**Subject: Additional Groundwater Monitoring Wells  
Addendum to Groundwater Investigation Work Plan, March 2011  
Bulk Fuels Facility Spill, Solid Waste Management Units ST-106 and SS-111  
Kirtland Air Force Base, New Mexico**

BULK FUELS FACILITY  
KIRTLAND AIR FORCE BASE, NEW MEXICO

FIGURE 3

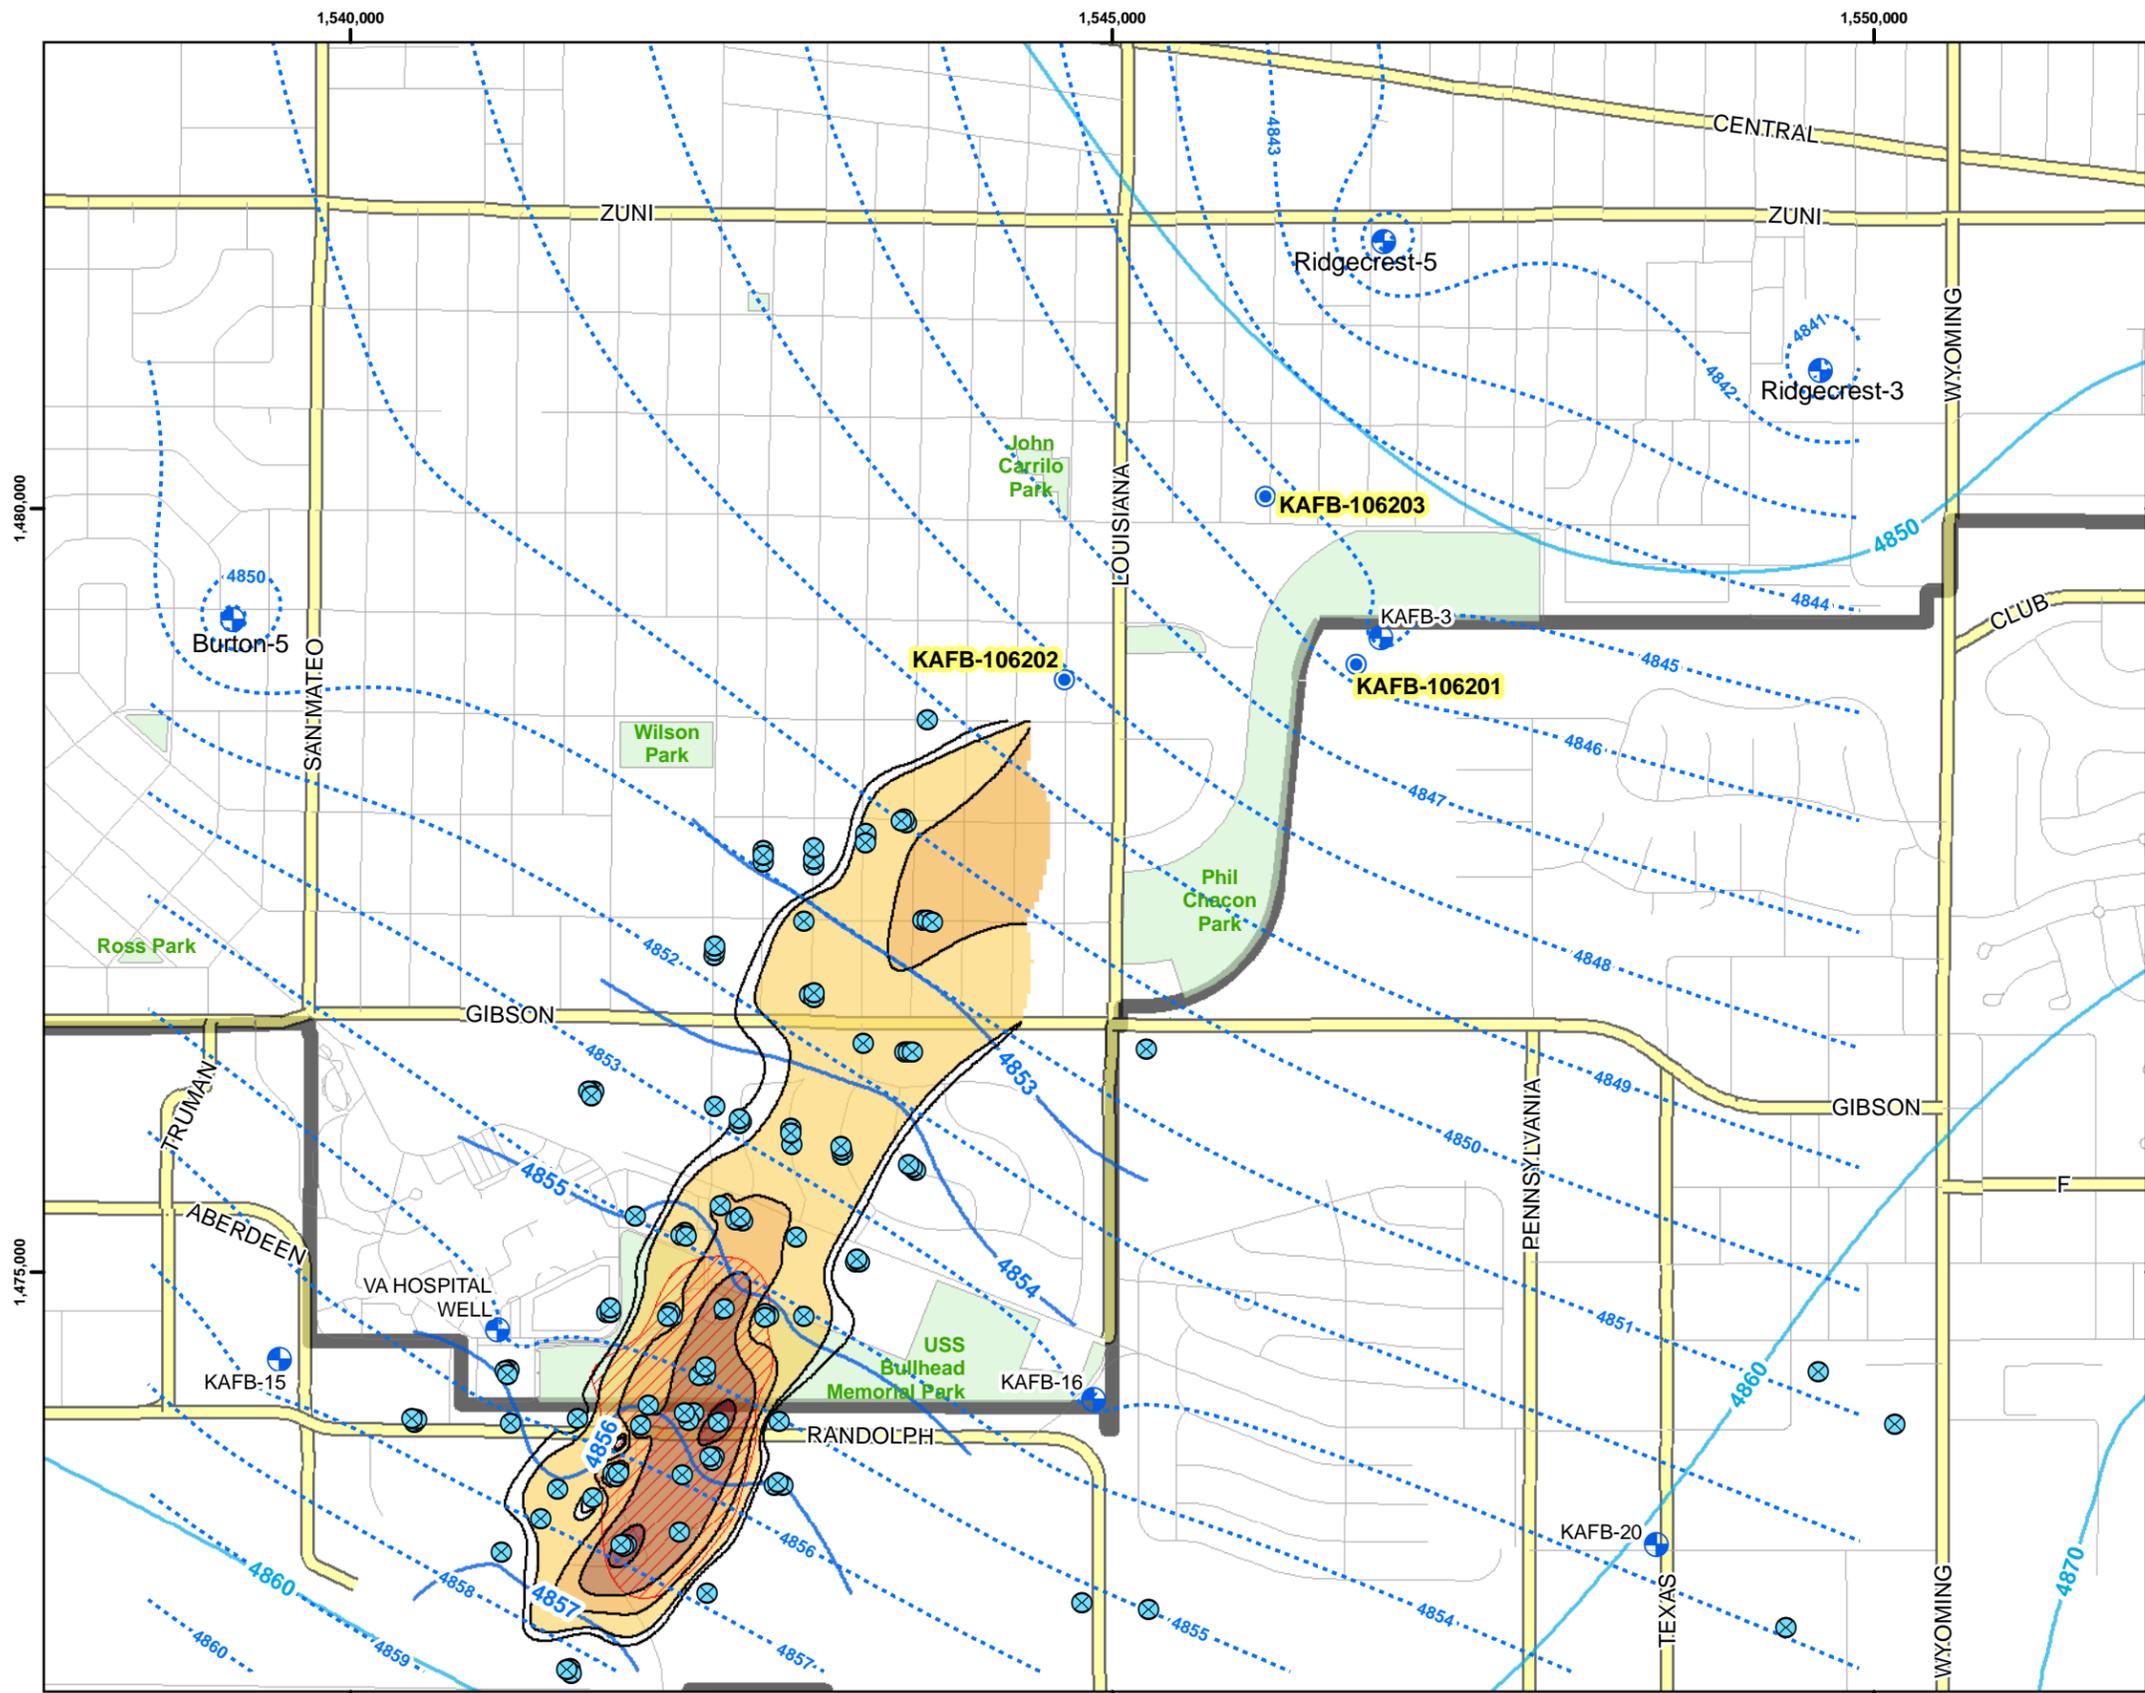
Figure 3 illustrates the proposed locations for three new groundwater monitoring wells (KAFB-106201, -106202, and -106203). Shaw proposes drilling and installing the wells with the same construction as the shallow groundwater monitoring wells, as described in Sections 4.2.3 and 4.2.4 of the Groundwater Investigation Work Plan. The well construction will include the change to a 30 foot screen length as approved in the 24 June 2011 new Mexico Environment Department (NMED) letter. Each of the three wells will also be geophysically logged following Section 4.2.5.
